FORT SMITH HISTORIC DISTRICT COMMISSION REGULAR MEETING MARCH 7, 2024, 5:30 P.M. DARBY COMMUNITY CENTER, 220 NORTH 7TH STREET

STAFF REPORT

A. Historic Name: Elizabeth McGill Center Owner: McGill Center, Inc.
Construction Date: c. 1942 Style Influence: Plain/Traditional

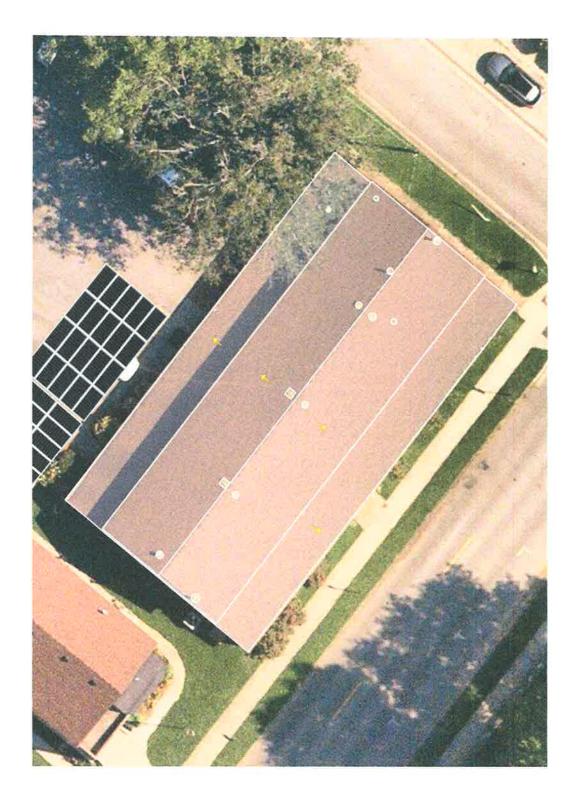
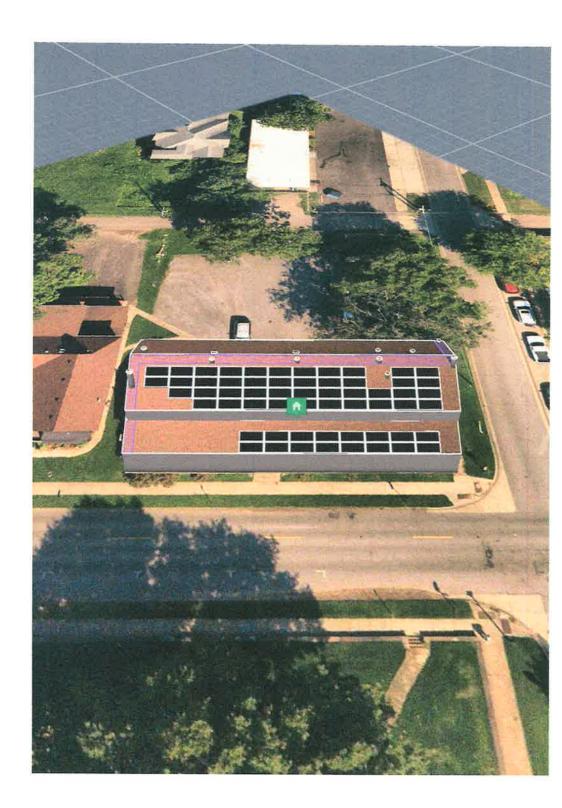
Section 3.10.1 of the Belle Grove Historic District Design Guidelines recommends minimizing the visual impact of mechanical and electrical equipment from view.

- Removal of historic roofing materials during the installation of solar systems
- Removing or otherwise altering historic roof configuration dormers, chimneys, or other features –
- to add solar systems.
- Any other installation procedure that will cause irreversible changes to historic features or materials.

Staff recommends approval contingent upon the solar panels being located at the rear of the property.
